SCS ENGINEERS

May 17, 2000
File No. 09195029.35

Subject: Response to Request for Additional Information
Southeast County Landfill Capacity Expansion - Section 1
Pending Permit No.: 35435-004-SC

Figure L-3. Design of Groundwater Monitoring Well.

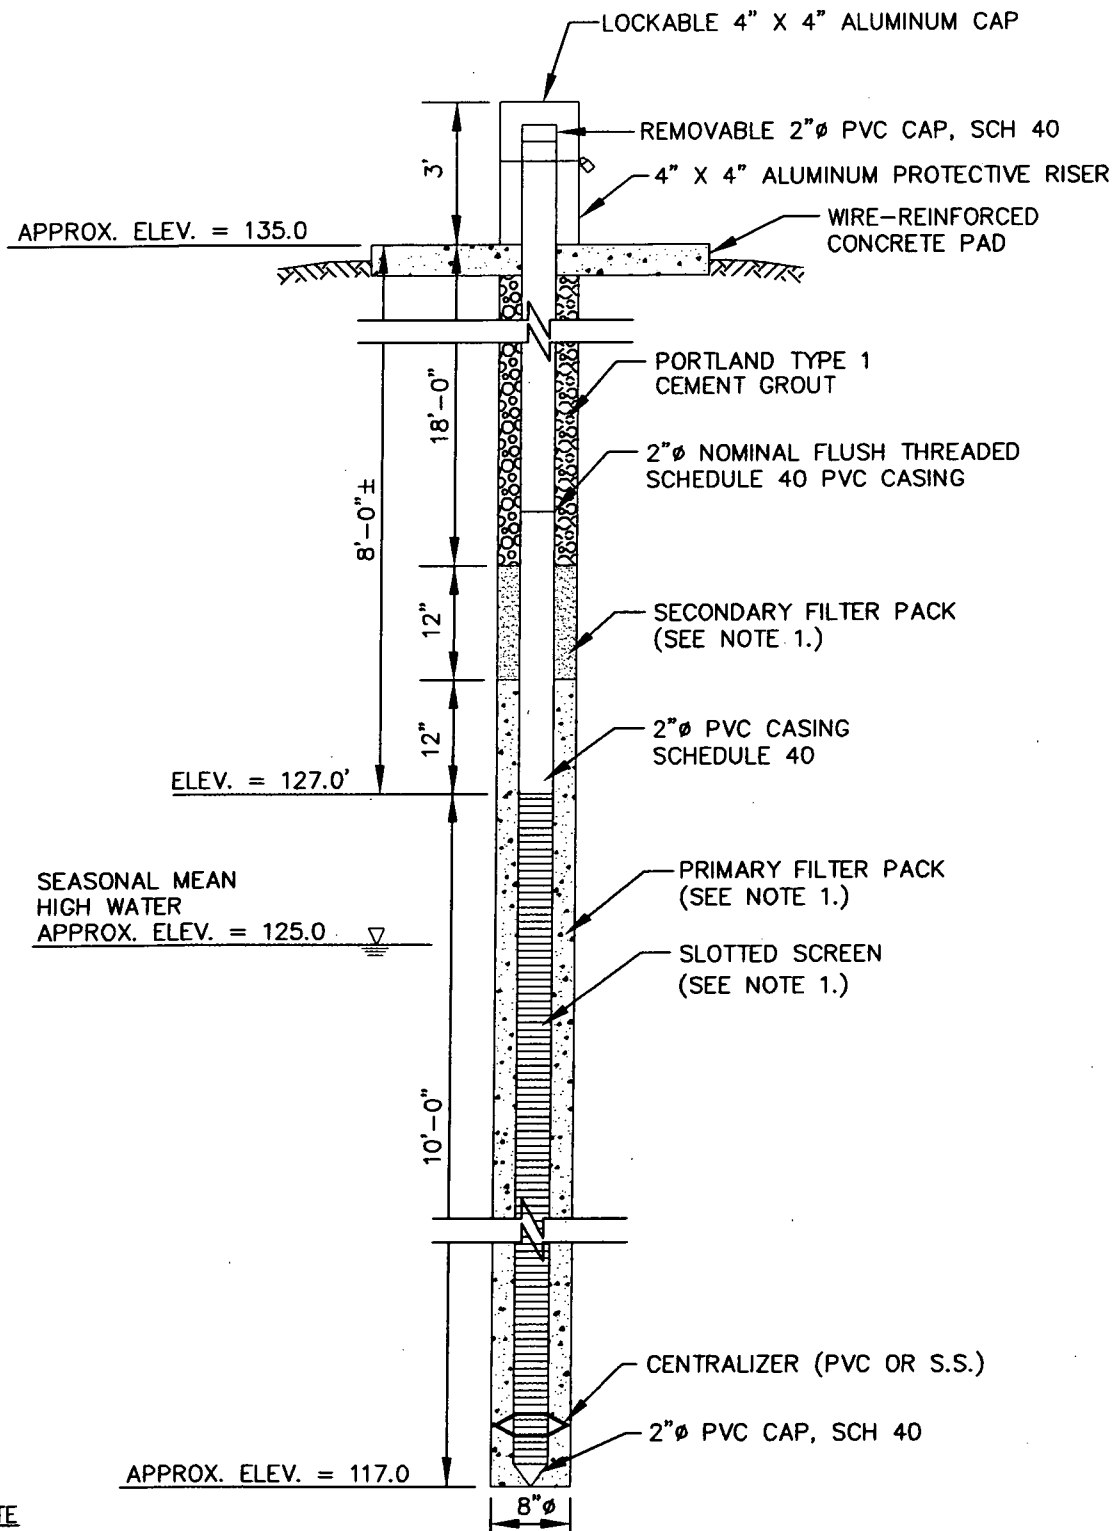
12. The text in this section indicates the proposed monitor wells shall be constructed with 10 feet of screen, placed so that approximately two feet of screen remains above the seasonal mean high water table. Figure L-3 identifies both the top and bottom of the screen at elevation 110 feet, and the approximate water surface at elevation 115 feet. Section I.1.c. indicates the average seasonal ground water surface ranges from elevation 118 to 121 feet. Please revise the text and figure as appropriate to allow review of proposed monitor well construction details.

Response: Figure L-3 has been revised to reflect the seasonal high water table of 125 feet NGVD and the text of Section I.1.c, Page I-7 has been revised (Attachment 15).
